Room 2 Hometel Manchester Piccadilly

Environmental Statement Addendum

July 2024

Northside (Manchester) Ltd

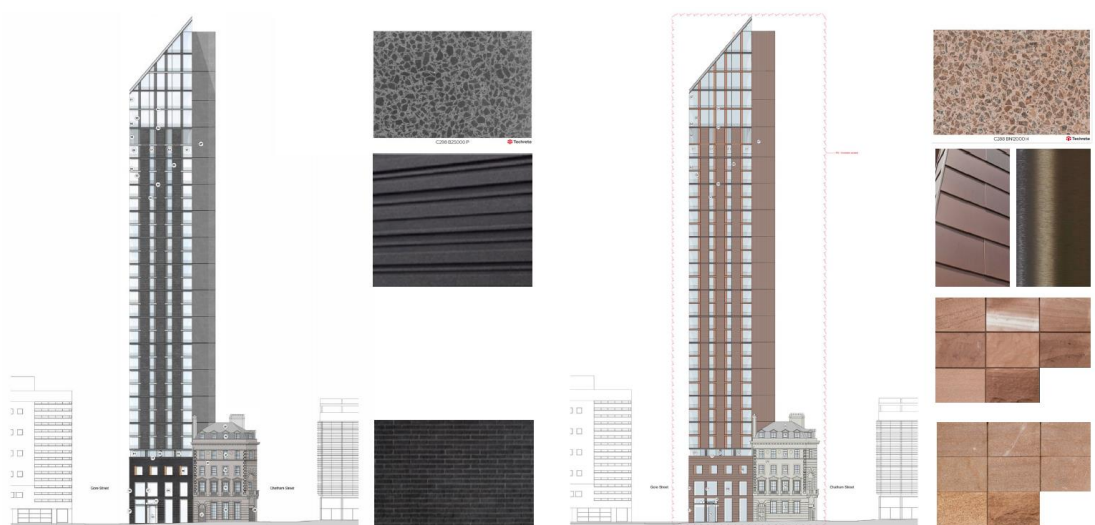
5.5 The key changes to the development are:

- Change of material to use a warmer tone for the precast concrete. A warmer red/ brown/ bronze colour for the tower and base has been selected.
- The light grey PCC aluminium side panels will be anodised aluminium.

- Replacement of brick at lower levels of the new build element with an all-precast solution/ local stone masonry including red/brown reconstituted stone (precast) and bronze anodised aluminium to the vertical side panels with wide joints reflecting the rustication of the bank building.

- Updated tonality, materials and textured treatment to the core. Colour change from grey to red/brown reconstituted stone (precast) or local stone masonry and bronze anodised aluminium vertical side panels.

Version of submitted view with grey precast and metalwork to tower

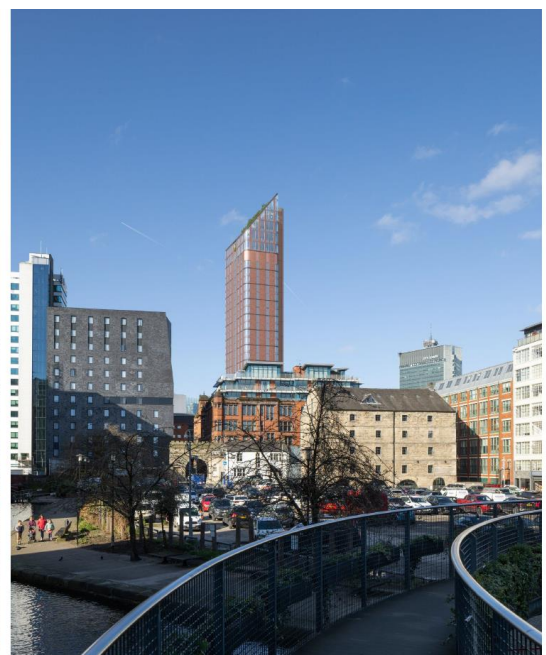
5.7 Concerns were raised by MCC regarding the tonality of the materials. An alternative warmer tone for the precast concrete is now proposed. The light grey PCC aluminium side panels have been replaced by anodised aluminium.

Amended view with alternative precast and metalwork to tower
